**BEFORE THE INDEPENDENT HEARING PANEL APPOINTED BY THE
QUEENSTOWN LAKES DISTRICT COUNCIL**

IN THE MATTER Variation to Queenstown Lakes Proposed District Plan - Urban
Intensification under Schedule 1 of the Resource Management
Act 1991.

**STATEMENT OF EVIDENCE OF ROLAND BRUCE HARLAND – URBAN
DESIGN ON BEHALF OF ALISTAIR HEY, CARL SMILEY, BARBARA JARRY
AND DUNCAN & TEIJA BOSCOE
04 July 2025**

Figure 1: *Urban Intensification Variation Proposed Zoning with Area to be retained as Lower Density Suburban Residential in red (fat line)*

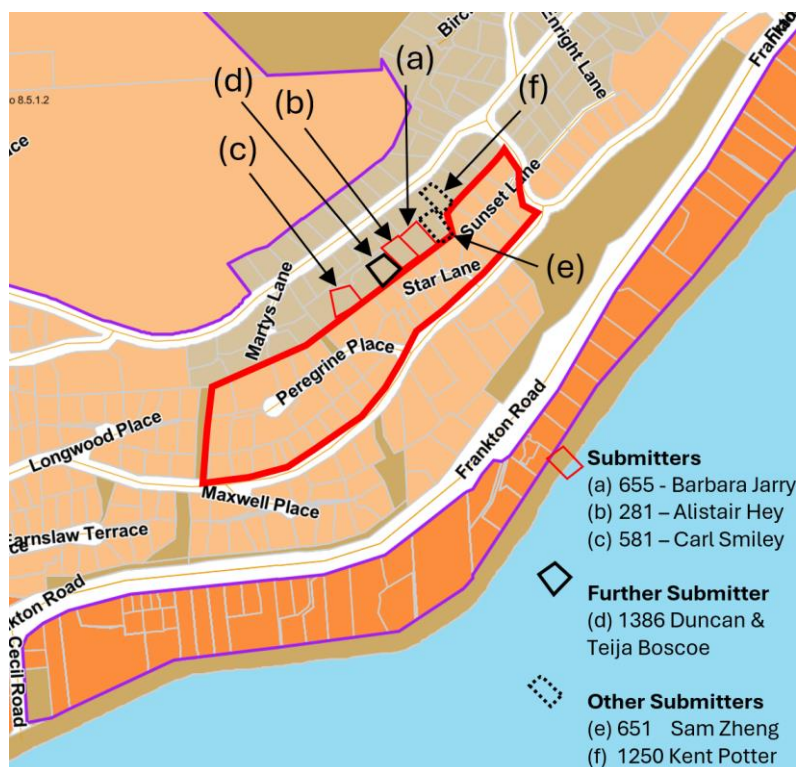
- 14 I have been engaged by original submitters 281 - Alistair Hey, 581 - Carl Smiley, 655 - Barbara Jarry and further submitter 1386 Duncan & Teija Boscoe to provide urban design evidence in relation to their submissions to the UIV. The location of these submitters and further submitter are shown on the following Figure 1 below. The

base map is taken from the notified UIV proposed zoning maps. The area highlighted in red (hereafter referred to as the subject land) is the area that the submitters seek to be retained as Lower Density Residential Suburban Zone (**LDSR**) as per PDP, noting that the submitters land is not proposed to be changed by the UIV. The area of MDRZ within the highlighted red area is approximately 3.0ha

- The relief sought by the submitters is that the subject land be retained as LDSR or, if that is not accepted, to apply a more nuanced approach to the interface between the zone boundary between the submitters' land and the MDRZ land on Star Lane and Peregrin Place.

Figure 2: *PDP and UIV zoning comparison. Area highlighted in Red is proposed to be maintained as LDSR*

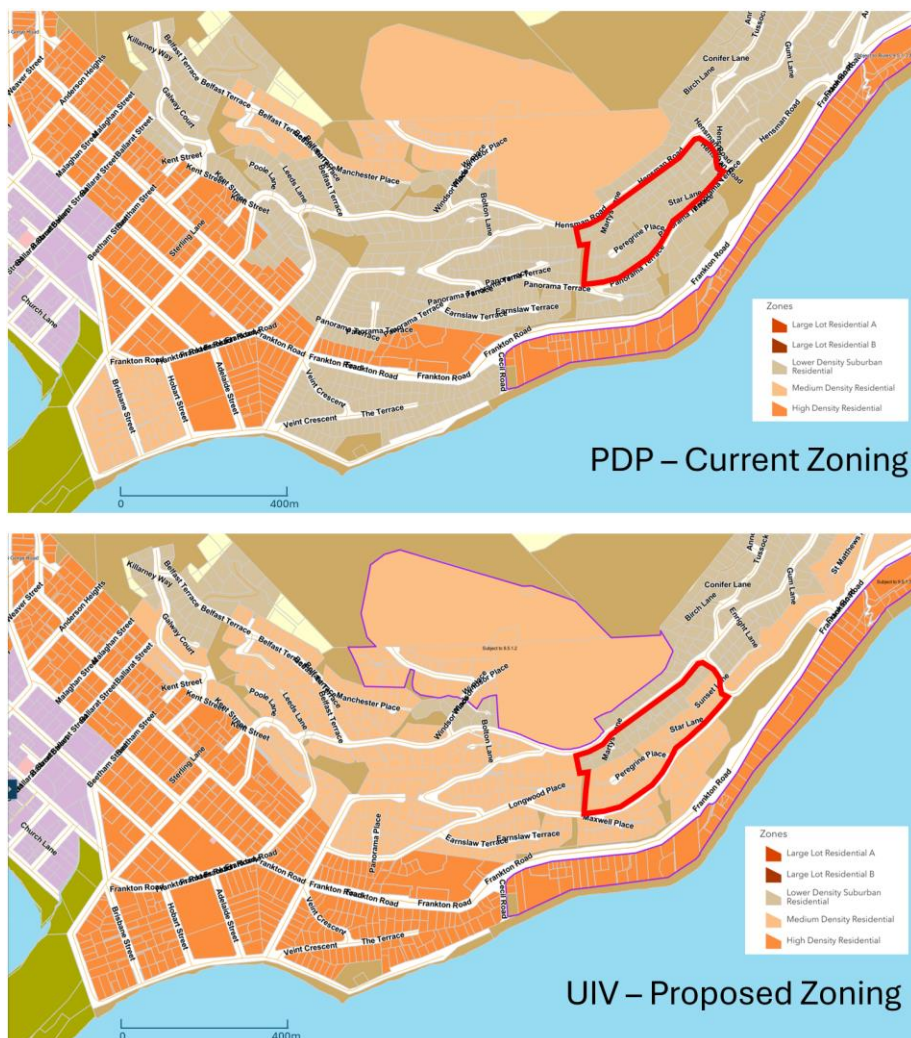
The area in question is shown on the following Figure 2, which shows the relative context and location and the comparison of the PDP and UIV zonings. The area highlighted in red is the area that is proposed to be retained as the lower density residential and is where the submitters I represent are located.

- 17 A more detailed map of the submitter's respective properties is included as Figure 1 above. The area of interest sits high on the hill above Frankton Road, with steep

circuitous roading access coming via Suburb St and Panorama Terrace to the west or Hensman Road to the east. Some of the gradients on these local residential streets are over 17% which is considered very steep. The area had been developed over the past 40 years with mostly standalone housing that typically spans 2-3 levels taking advantage of the steep sloping nature of the land and the expansive views generally to the south. Extensive views across Lake Whakatipu and to wider mountain ranges such as The Remarkables and Cecil Peak are significant amenity features that are highly valued by residents in this locality and from public streets. As discussed in detail in paragraphs 25-37 of my evidence the subject area is circa 2km from Queenstown Town Centre, which is a steep and challenging walk that is well outside typical 5-10 minute walking distances of 400-800m²

Figure 3 Overall Accessibility Map (Base Map sourced from QLDC Story Map)

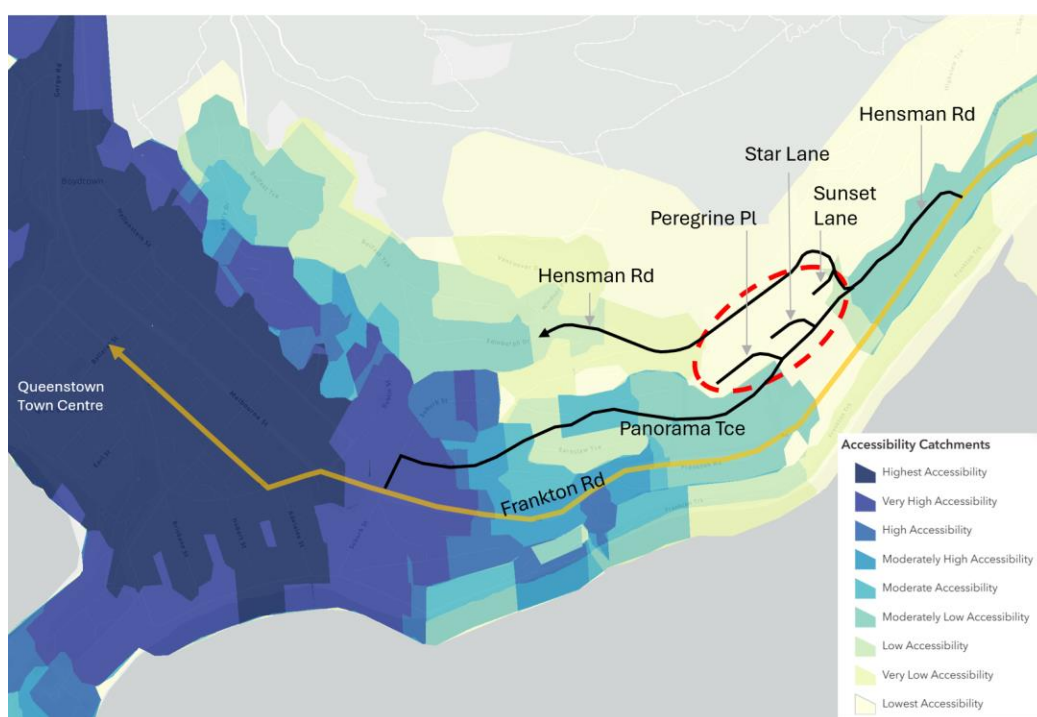
- 27 It is clear in Figure 3 above that the Council’s own accessibility mapping analysis identifies the land in the vicinity of Hensman Road, Star and Sunset Lane and Peregrine Place as having the lowest accessibility ranking. Mr Wallace in 4.3 of his s42a evidence identifies and lists a range of physical proximity factors that were considered in determining the accessibility analysis. In Appendix 2 - Accessibility & Physical Proximity of my evidence, I have included the list from Mr Wallace’s evidence and added further comments with respect to the accessibility and physical proximity of the subject land area to wider points of interest. The detailed breakdown

Figure 3: Accessibility by Bus around Queenstown Town Centre and Frankton with darker blue colours highlighting the areas most accessible by buses

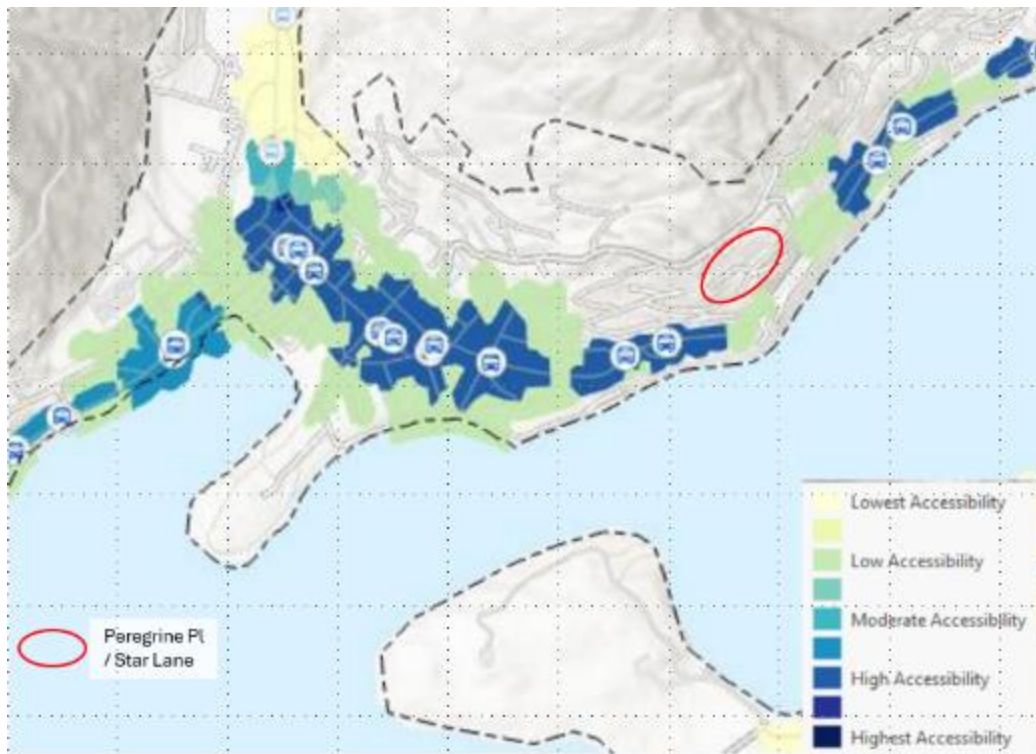
- 37 Walking times from Star Lane & Peregrine Place vary from 8-14 minutes while Sunset Lane is slightly closer with walking times of 6-10 minutes. Walking times to bus stops is one measure of accessibility and adding in waiting times for the bus, and bus travel time adds significantly to overall travel times. Furthermore the 14.4% gradient up Hensman Road would be a major barrier (notwithstanding frost/ice factors) to a substantial portion of the population thereby reducing overall accessibility by walking and public transport options. This low public transport accessibility is also confirmed in Mr Wallace's s32, appendix 3 (section 5.4.7) and paragraph 15.10 of Mr Mt Wallace's s42a evidence, where he has mapped the accessibility by bus around Queenstown Town Centre and Frankton. I have enlarged a portion of his Figure 5 (from s42a evidence) below (Figure 3) and added in the location of the Peregrine Place, Star and Sunset Lane area in red for reference. In my opinion due to the low accessibility rating, adding additional population into the subject area would not be in keeping with a well-functioning urban environment.

Appendix 1: Excerpt from s32 Evaluation Report - Appendix 3 Memorandum:
Method Statement – Accessibility & Demand Analysis – NPS UD Policy 5 (Base
Map is from Figure 16 – Total Accessibility (Weighted))

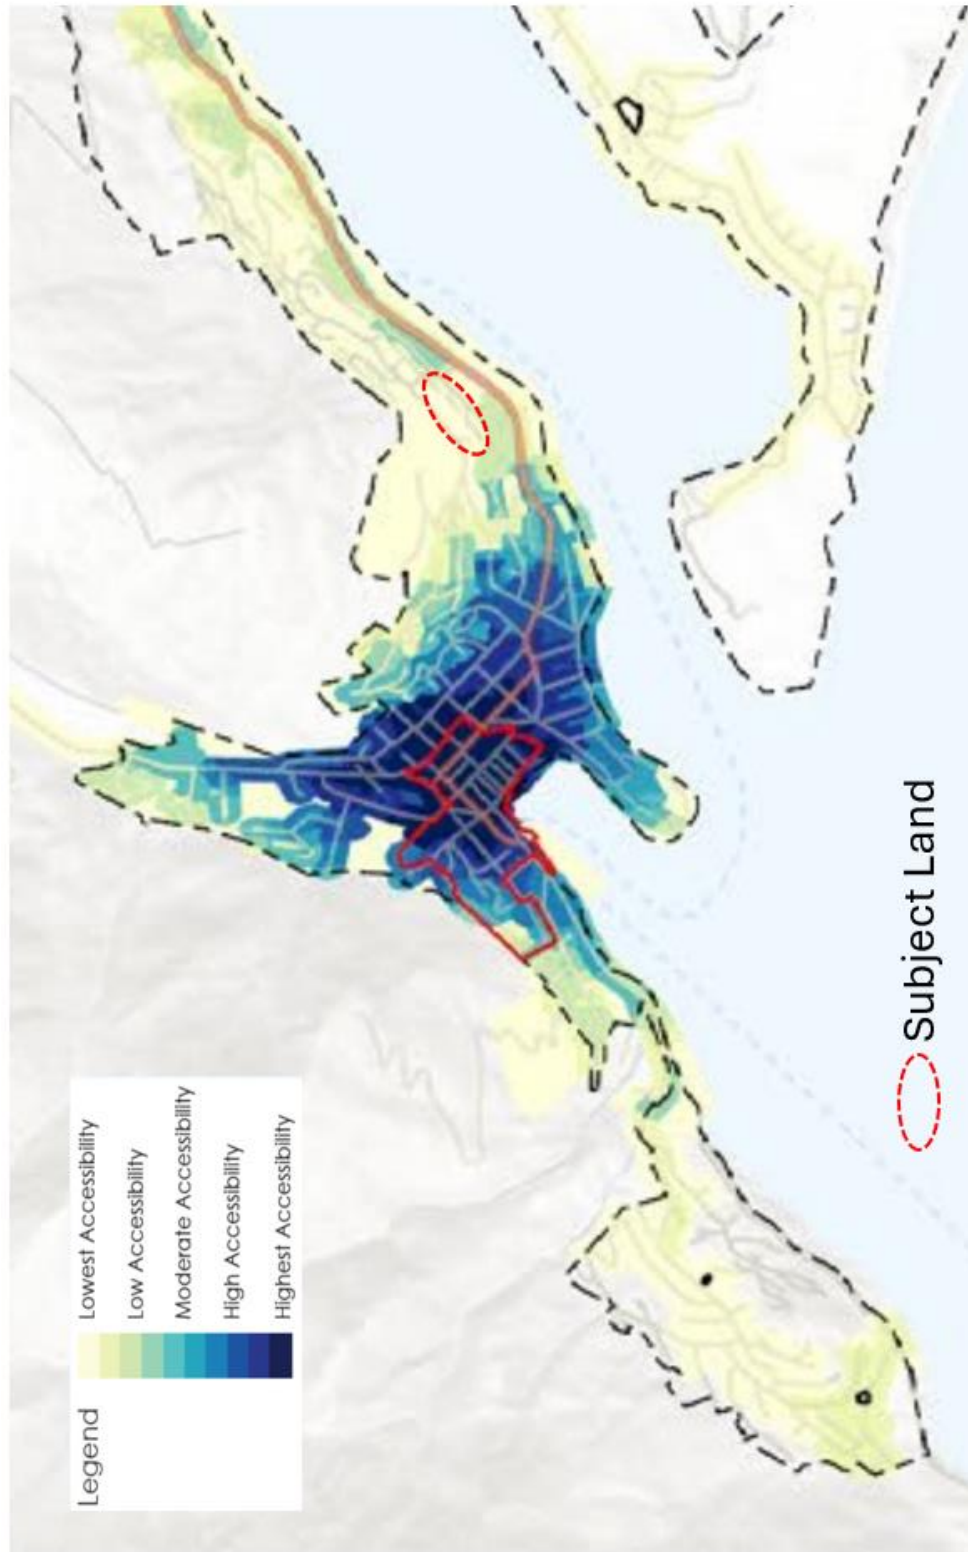
- 25 A key justification for the Council’s application of upzoning in response to the NPS-UD is the extensive Accessibility and Demand Analysis undertaken, which is explained in detail in the s32 Evaluation Report - Appendix 3 Memorandum: Method Statement – Accessibility & Demand Analysis – NPS UD Policy 5. This analysis looked at a range of weighted factors including, walkability to a number of destinations including town centres, schools, parks, medical services, employment, supermarkets and existing and planned public transport. Appendix 3, section 7.0 of the s32 Evaluation Report provides a summary map [Figure 16 - Total Accessibility (Weighted)], which identifies the subject land as having the lowest accessibility rating.

I have marked up an enlarged version of the Figure 16 plan highlighting the location of the subject land. (Refer to Appendix 1 of my evidence).

Appendix 3 Map of Accessibility & Proximity

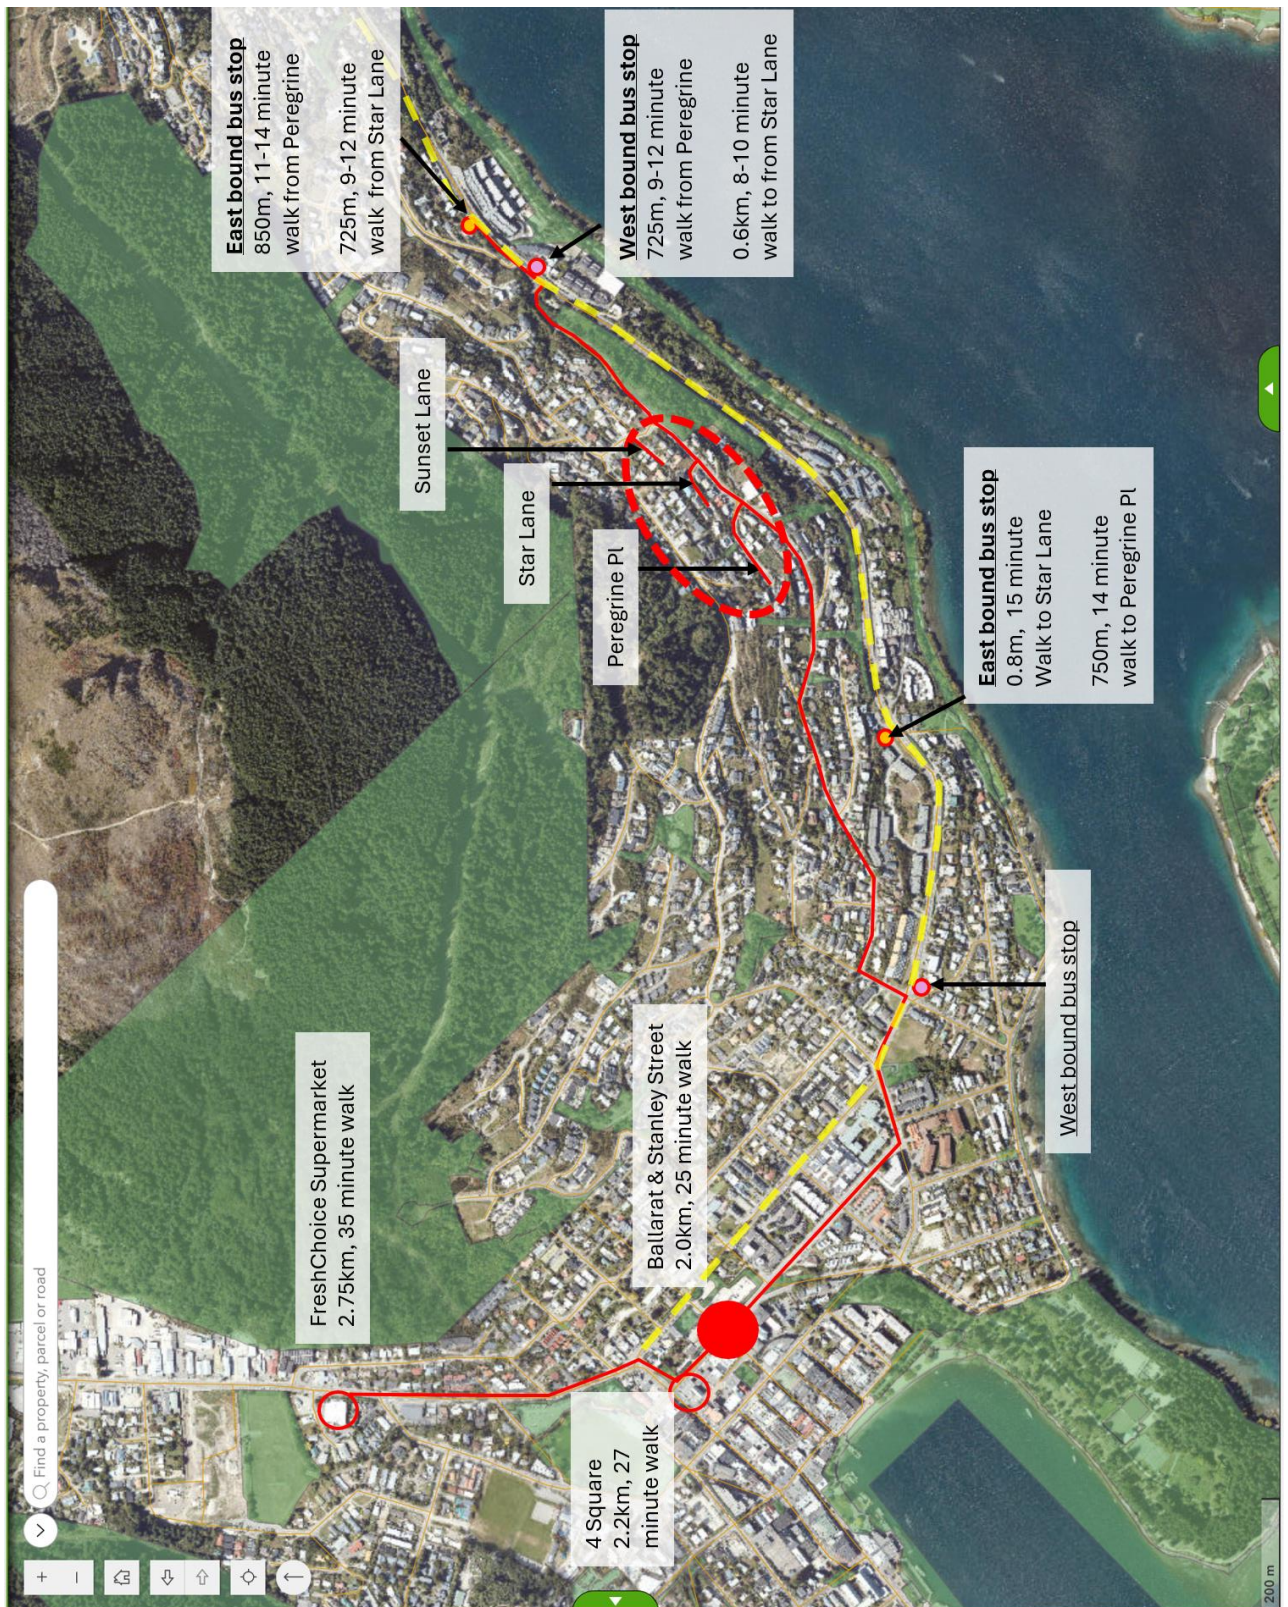
Further discussion of the accuracy of these walking times to reflect local context of steep gradient challenges are discussed in paragraph's 33-37. Appendix 3 of my evidence also contains a map depicting many of the points of interest for reference.

- 28 It is clear from Appendix 2 and 3 in my evidence that the subject area is well outside the walkable catchment to key destinations. I have discussed access to public transport in paragraph 36, which demonstrates that access is constrained by distance and gradients.
